GROUP	MODEL
CHA	2022MY Forte (BD/BDm)
NUMBER	DATE
115	July 2022

TECHNICAL SERVICE BULLETIN

SUBJECT: **SERVICE ACTION: BRAKE PEDAL ASSEMBLY INSPECTION AND REPLACEMENT (SA501)**

Inspection Procedure:

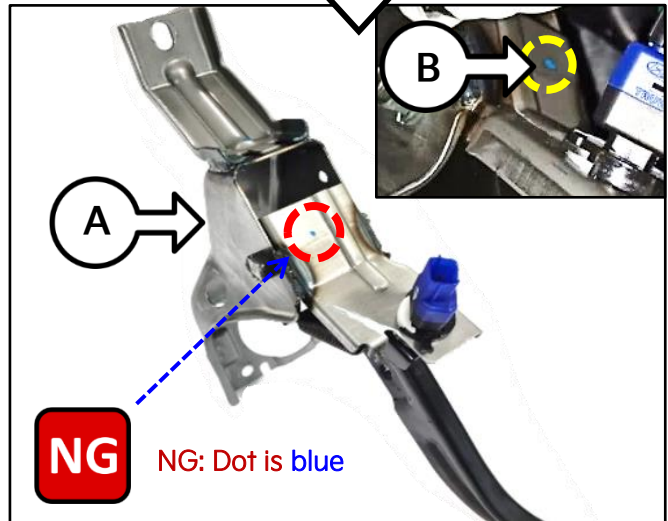
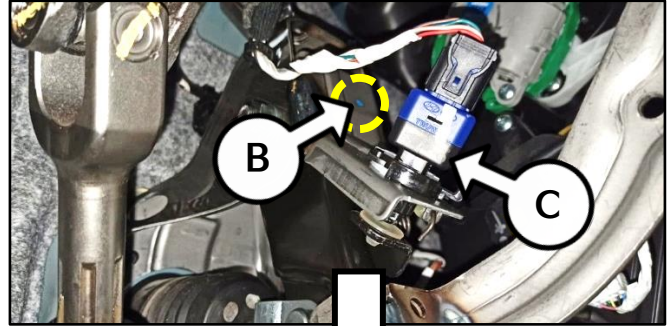
- 1a. Locate the brake pedal assembly (A) and look for a painted blue dot (B) on the flat surface of the brake pedal assembly bracket, above the brake pedal switch (C) where shown.
- 1b. Identify the color of the dot on the area shown:
 - **Blue (NG):** Proceed to the 'Replacement Procedure' below to replace the brake pedal assembly.
 - **Other color (OK):** If the dot is any color other than blue, this service action is complete. No further action is required.

Replacement Procedure:

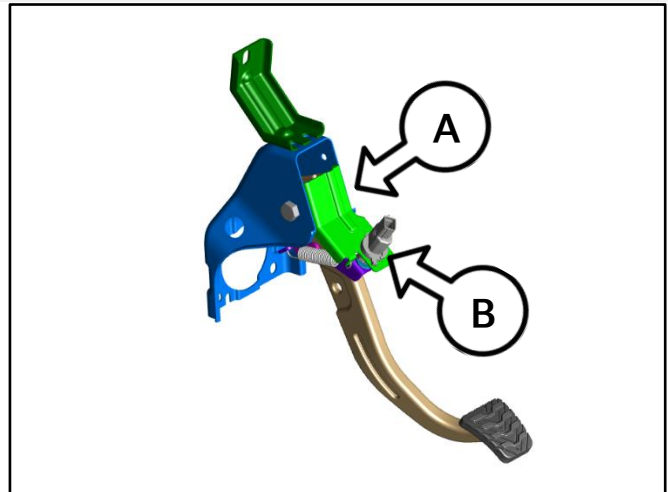
1. Remove and replace the brake pedal assembly (A) by referring to the "Brake System → Brake System → Brake Pedal → Repair procedures" chapter in the applicable Shop Manual on KGIS.

Note: The new brake pedal assembly also includes a new 'pre-adjusted' brake switch (B).

Tightening torque for mounting nuts:
12.3 - 18.8 lb.ft (16.7 - 25.5 N.m)

2. Reinstall all removed parts in reverse order of removal.
3. Confirm normal operation of the brake pedal and brake lights.
